**Planning Board**

**Thursday, June 18, 2026: 6:00 PM**

# Planning Staff Report

**Item:** **File #PD-04-26** Review of the Preliminary Development Plan (PDP) for Phase 3B of the Ace Hardware Planned Development

Figure 5: Proposed Plan Layout of Phase 3B (Full PDP Plan Attached to this Report)

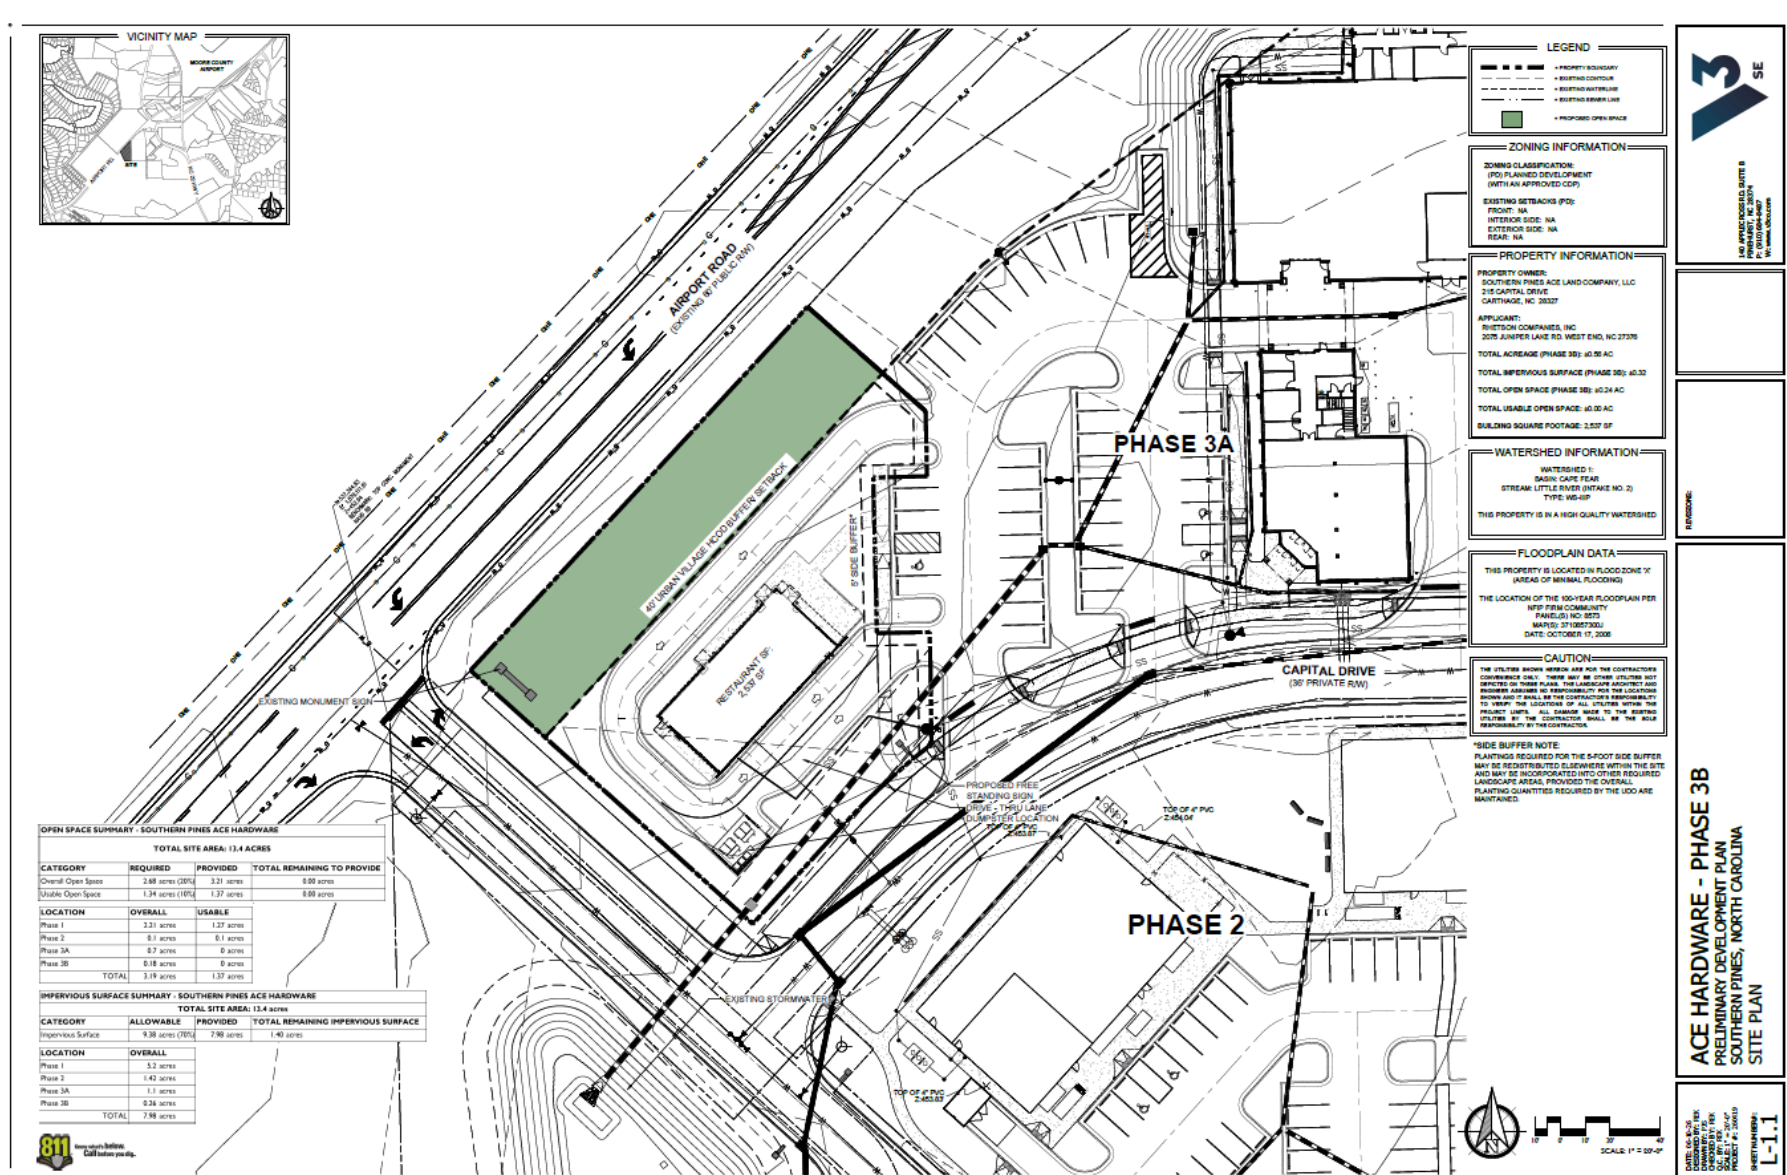
**Highway Corridor Overlay Standards.** Modification 1: Due to the ambiguity of the approved site plan in Phase 3A PDP showing the Urban Village Highway Corridor Overlay buffer continuing into the Phase 3B parcel, Planning Staff supports shifting to Urban Village Highway Corridor Overlay standards for this phase. This means that for Phase 3B, the parking area setback and building setback are 40 feet, and the side/rear yard buffer for non-residential zones is 5 feet.

**Landscape Standards.** Phase 3B must conform to all applicable standards outlined in UDO Chapter 4, except for the Planned Development-specific standards mentioned in UDO section 3.5.14(H). Modification 2: The side and rear yard buffer applies to the property line between Phase 3B and 3A. Planning Staff supports that the required plantings for this 5-foot buffer shall be dispersed or moved to alternate locations on the site instead of following the property line, as agreed by staff and applicant. This is outlined under the Buffers/Setbacks section of the applicant's narrative. The applicant also added a note to the preliminary site layout that plantings required for the 5-foot side buffer may be redistributed elsewhere within the site...provided that the overall planning quantities required by the UDO are maintained, to prevent any ambiguity.

- ii. Modification 1 - Changing the parking and building setback to follow Urban Village instead of Urban Transition standards, consistent with the previous development Phase 3A, resulting in a landscape buffer, building setback, and parking area setback of 40 feet.

- iii. Modification 2 – Consistent with Urban Village HCO standards, the side/rear yard buffer of 5 feet from residential zones is applicable. This buffer would be required between the parking lot of Phase 3A and 3B. Allow the dispersion of the required buffer plantings elsewhere on the site.

ACE HARDWARE - PHASE 3B  
PRELIMINARY DEVELOPMENT PLAN  
SOUTHERN PINES, NORTH CAROLINA  
SITE PLAN

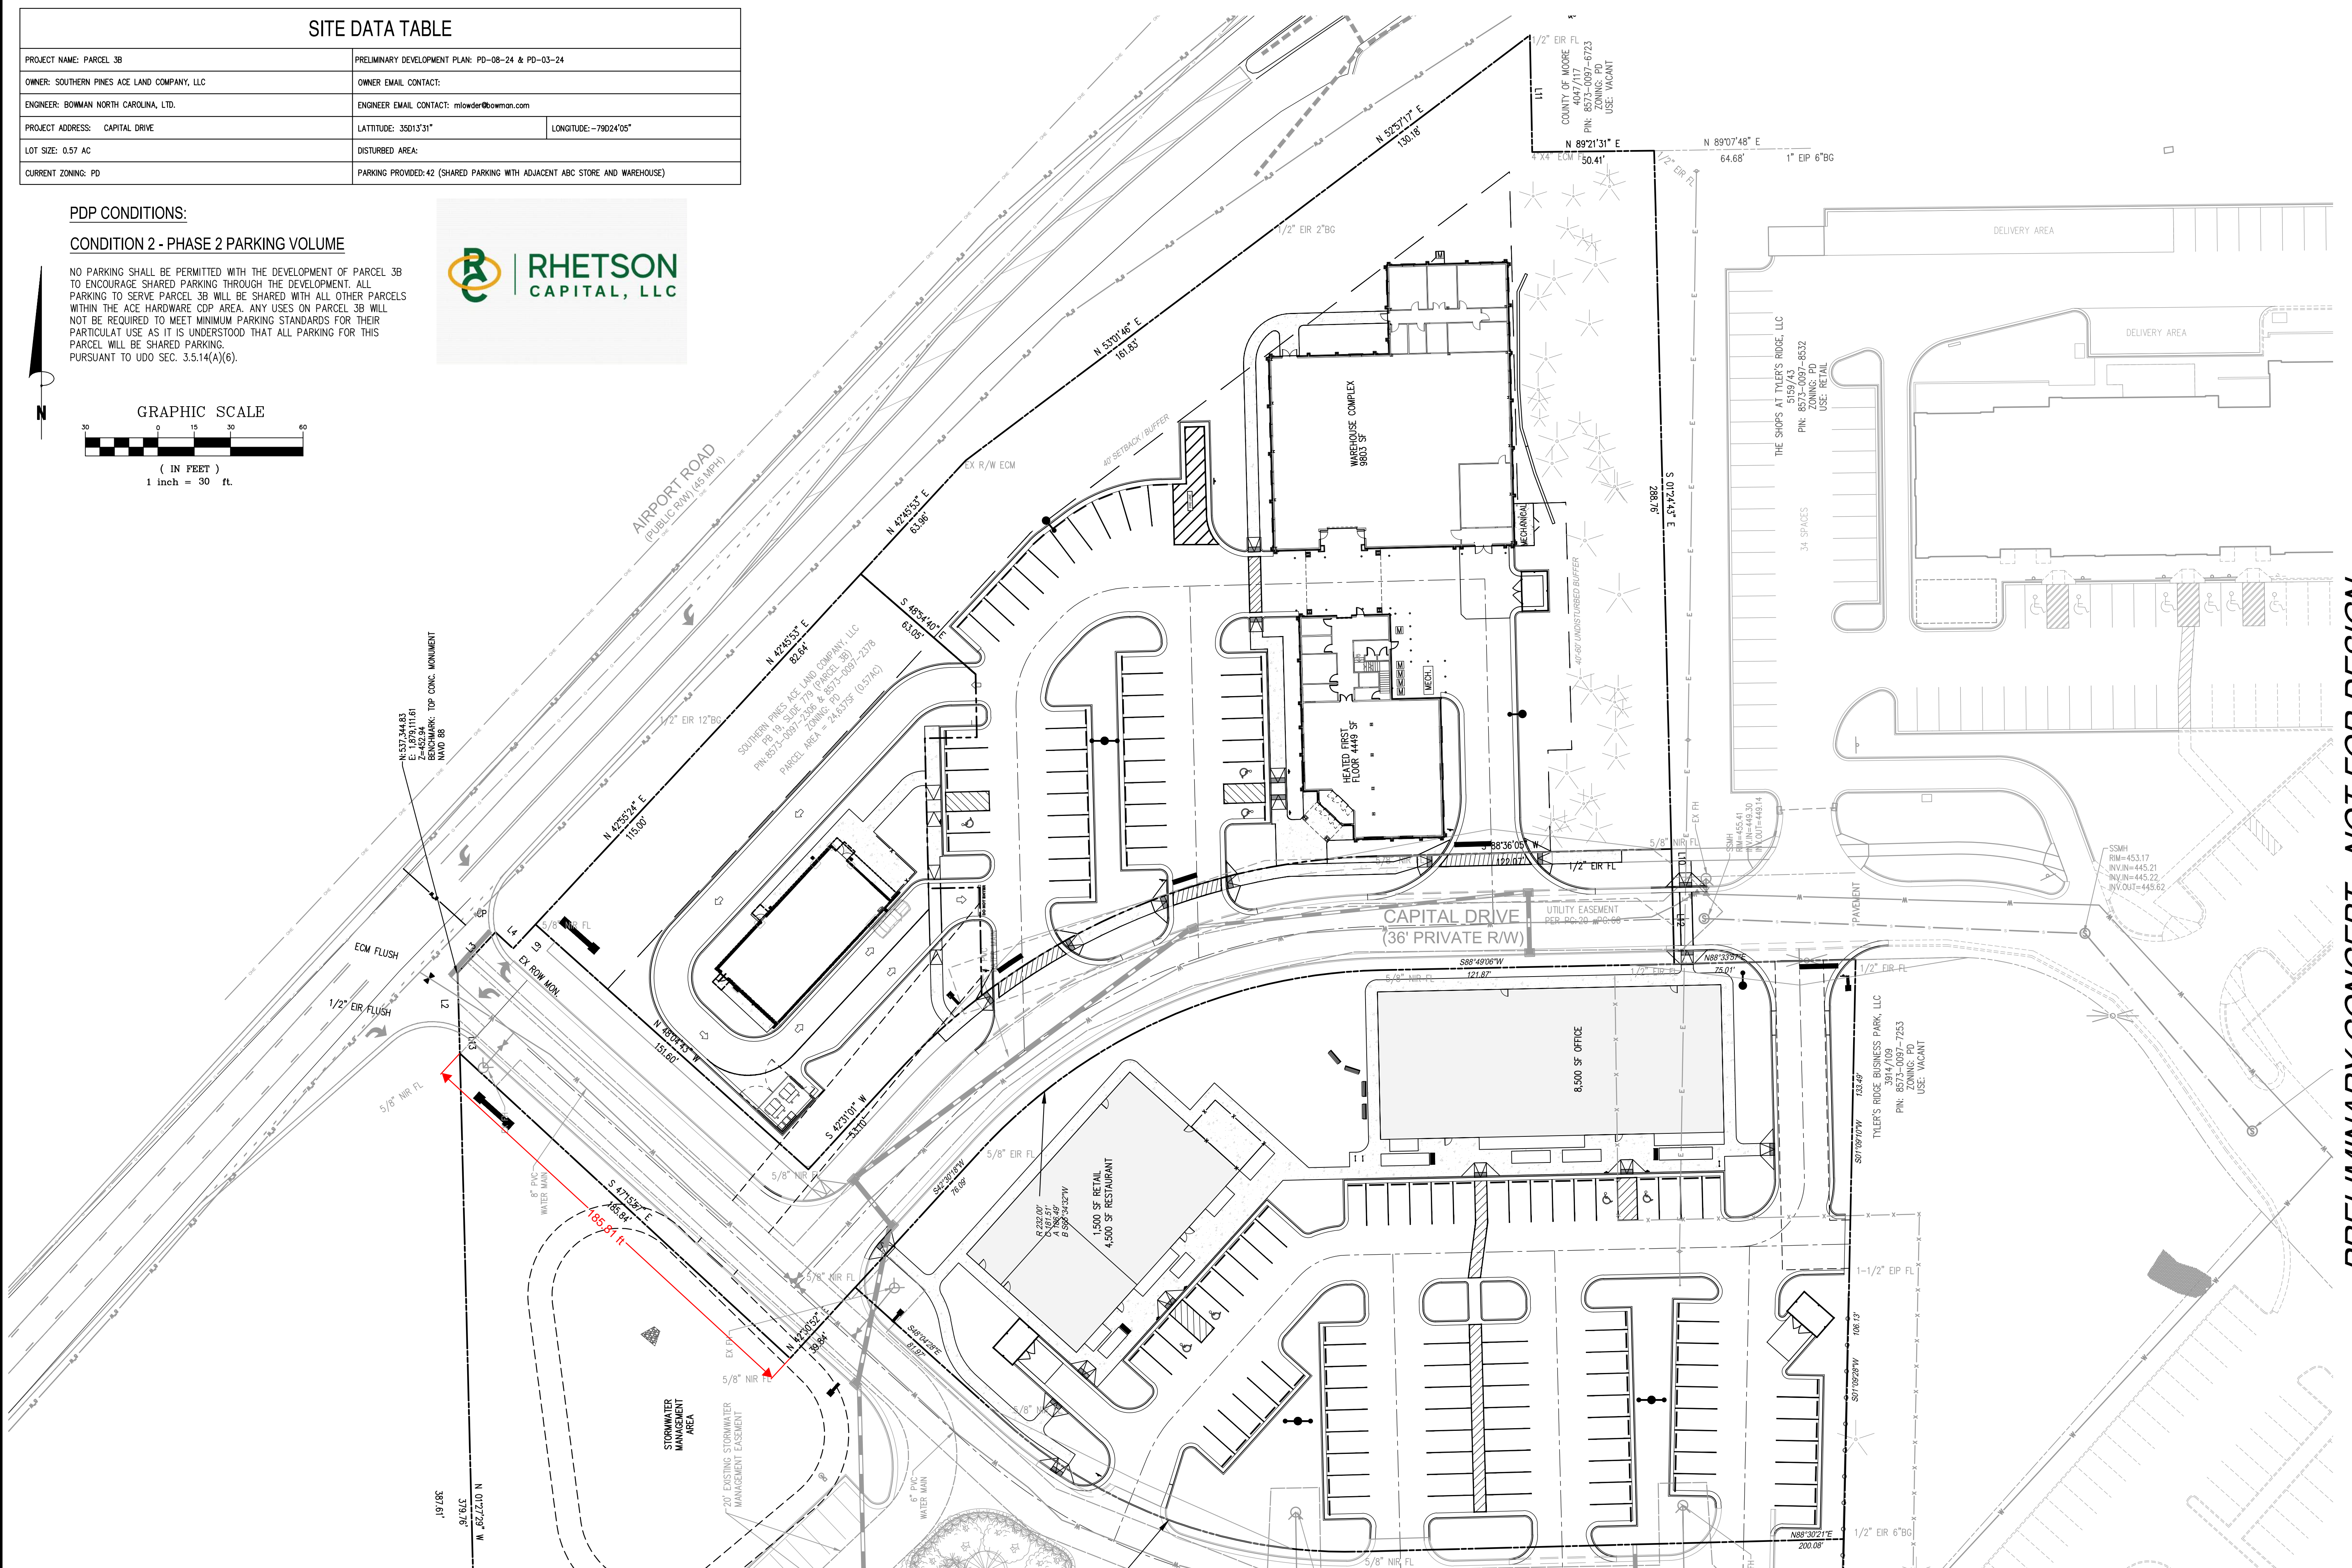
- Urban Village Highway Corridor Overlay standards require a 5-foot buffer between Phases 3A and 3B. However, due to the integrated design, shared parking, and interconnected circulation between the two phases, both the applicant and planning staff determined that installing a physical buffer between them would not be consistent with the intended function and cohesiveness of the development. Instead, it was agreed that the landscaping and planting materials otherwise required within this buffer area would be redistributed to other locations throughout the site, maintaining the overall landscaping intent while supporting a unified site design

PLANTINGS REQUIRED FOR THE 5-FOOT SIDE BUFFER MAY BE REDISTRIBUTED ELSEWHERE WITHIN THE SITE AND MAY BE INCORPORATED INTO OTHER REQUIRED LANDSCAPE AREAS, PROVIDED THE OVERALL PLANTING QUANTITIES REQUIRED BY THE UDO ARE MAINTAINED.
